RIDGWAY PLANNING COMMISSION AGENDA

Tuesday, March 27th, 2018 Planning Commission Regular Meeting: 5:30 pm Ridgway Community Center 201 North Railroad Street, Ridgway, Colorado

Request: Sketch Plan

Applicant: Ridgway Cohousing, LLC
Owners: Ridgway Cohousing, LLC
Initiated By: Shay Coburn, Planner
Date: March 27, 2018

ALPENGLOW CoHOUSING: SITE PLAN

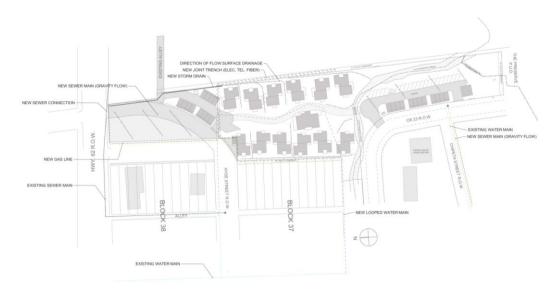
Setbacks vary from 0 ft. to 8' depending on how drainage is accommodated. Setbacks appear to be larger than 8 ft. for the larger parcel according to the site plan but we will need exact measurements on the preliminary plat.

Parking — Under RMC 7-3-10(A), 2 parking spaces are required for residences greater than a studio size of 600 sf. All 24 units are above 600 sq. ft. thus requiring a minimum of 48 spaces, which are provided in a combination of garages and carports. However, the parking matrix was updated since the previous sketch plan submittal and it designates 6 spaces as "Guest Parking." This means that 6 units do not have the required 2 parking spaces. In addition, the applicant is proposing to improve the public right-of-way along CR 23 which will add some guest parking. We will need clarification as to what these improvements will look like, how many additional spaces will be added, and if this is still part of the overall plan.
